# Item D1 Cable stay foot/cycle bridge, east of Junction 9 of the M20 Motorway, Ashford – AS/10/20

A report by Head of Planning Applications Group to Planning Applications Committee on 13 April 2010

Application by Kent Highway Services for a cable stay footbridge over the M20 Motorway to the east of Junction 9 between Eureka Leisure Park and Warren Retail Park, Ashford – AS/10/20

## i. Southern Approach

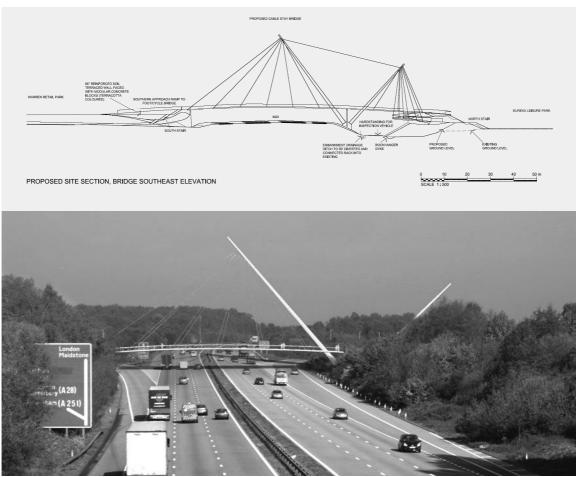
I have some concerns over the materials to be used for the retaining walls and parapets, especially the combination of terracotta and beige concrete block work with red brick on the proposed mound and ramps (see Dwg B0973500/PA/005). Further details of the actual bricks and blocks are required and elevations showing the detailing of materials should also be submitted. I also recommend that the handrails, balustrade and lighting on the ramps should be of a related design/materials to that used for the main span of the bridge to give continuity and strength of design overall.
